EPRI Perspective on BTP Direction

WM2012
February 26- March 2, 2012

BTP - US NRC Branch Technical Position on Concentration Averaging and Waste Form

Homogeneity Tests

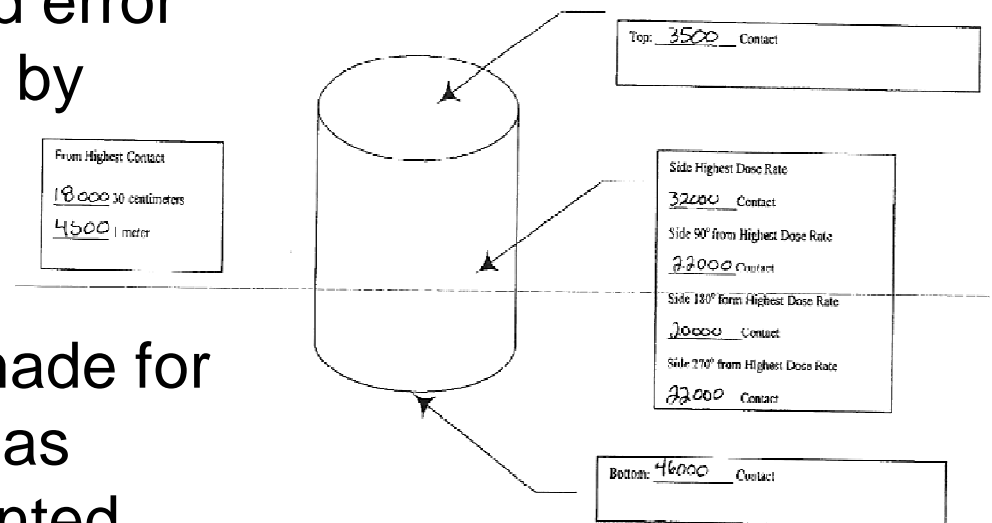
- Waste layering in resin tanks and liners is inherent by design and will have varying dose rates.
- These layered dose rates will not pass the proposed standard error test and cannot be avoided by design
- To imply that additional considerations should be made for wastes that are predefined as homogenous are not warranted and are driven by an unrealistic well drilling scenario

Activated Hardware (Single Component Constraint)

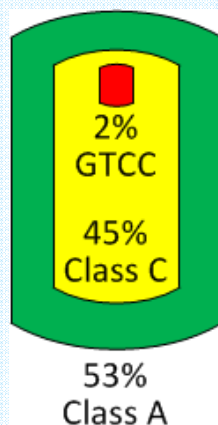
Averaging over a single component does not consider overall risk

**~100 Rem dose to
real workers – due
to segmentation**

**~100 Rem dose (or
more) to real
workers averted –
No Segmentation**

Allow averaging over similar and adjacent components when all pieces are $>0.01\text{ft}^3$ and placed in the same package
